PERMIT NUMBER: B 22054026

### RESIDENTIAL BUILDING PERMIT APPLICATION

Existing Use: **single family home** Proposed Use: **detached workshop & bathroom** Estimated Cost: **\$75.00**  
 Trade Work to Be Completed (Separate Permits Required):  Mechanical (HVACR)  Electrical  Plumbing  None  
**SFD/ construct 26'x14' workshop- not garage with storage room & bathroom 364sq ft**

Changes to permit B22004026

# FOUNDATION PLAN

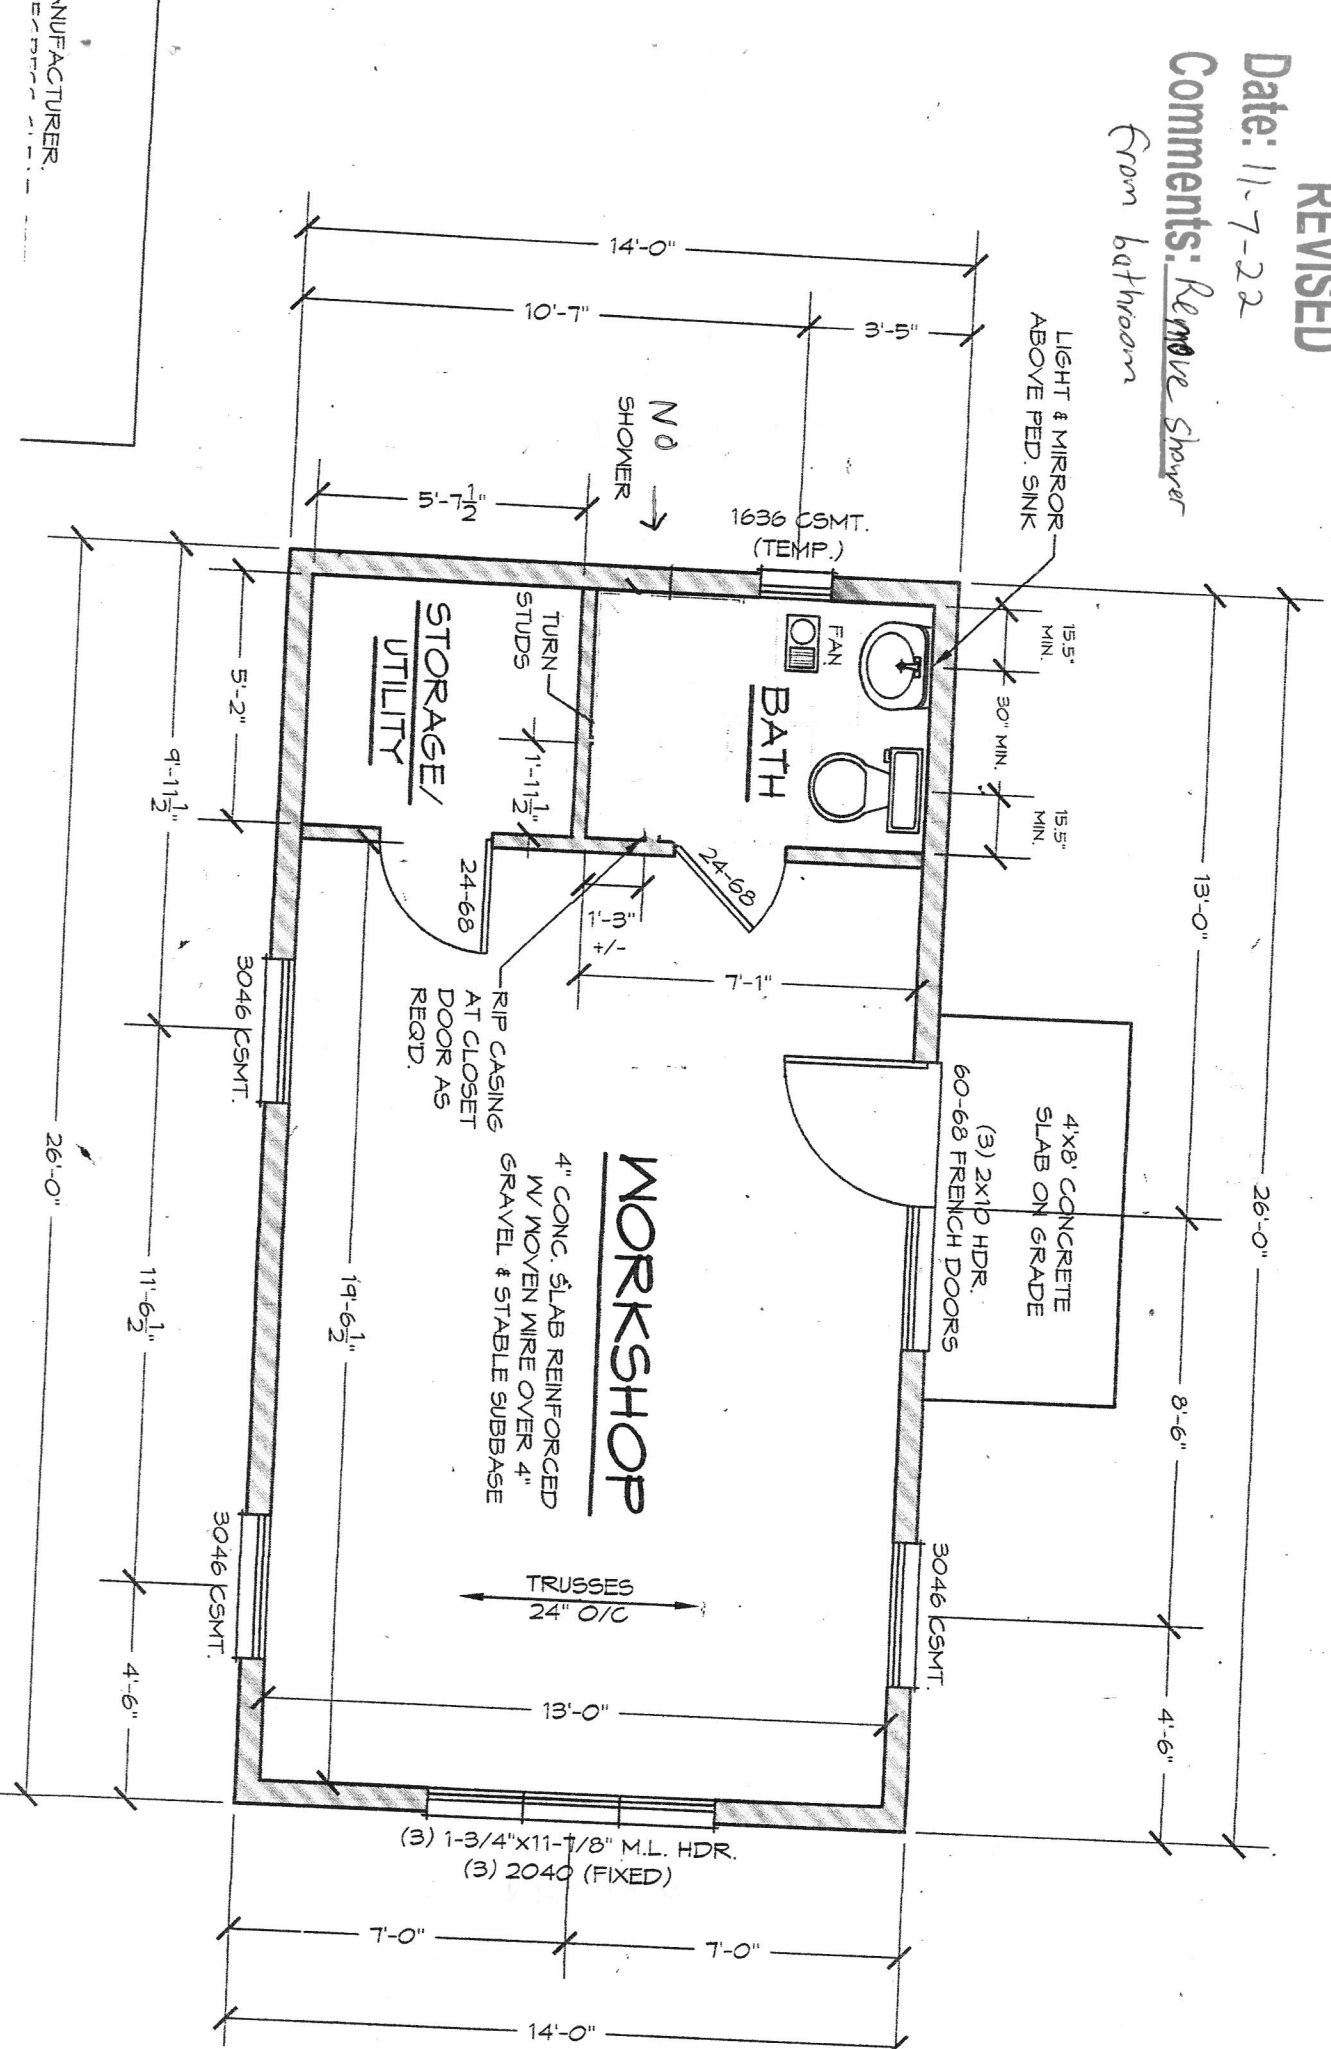
Originally planned to have a shower in the bathroom of this room, this is the official notice that we are deleting the shower from this plan.

Comments: Remove Shower  
From bathroom
